Access Compliance Report

Public Rights-of-Way

| Intersection ID: 7832 | Main Street: FARMFIELD_LN | Cross Street: OLD_CONCORD_RD | Location: W |
| ADA ID: 393C64FF2C51 | Ramp Type: Perp | Initial Pass/Fail: Fail | Overall Compliance: No |

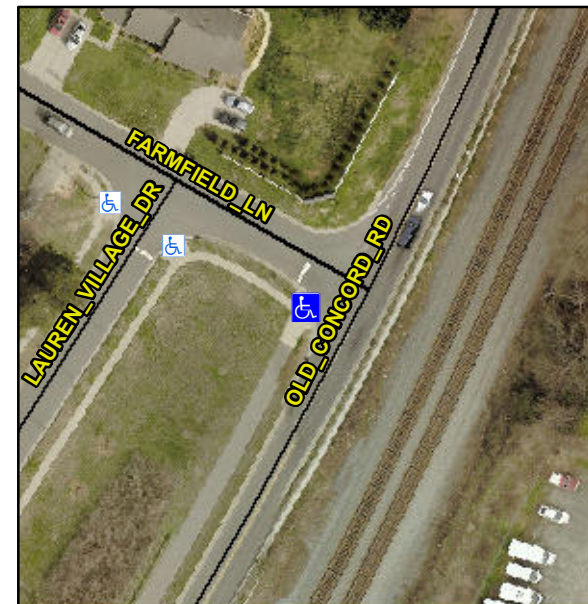
Not Found, R304.5.3

| Compliance | Description | Data | Compliance | Description | Data |
|------------|-----------------------|-------|------------|-----------------------------|------|
| Yes | Ramp Width (in) | 64.0 | No | Ramp XSlope (%) | 4.3 |

Remove & Replace Entire Ramp.
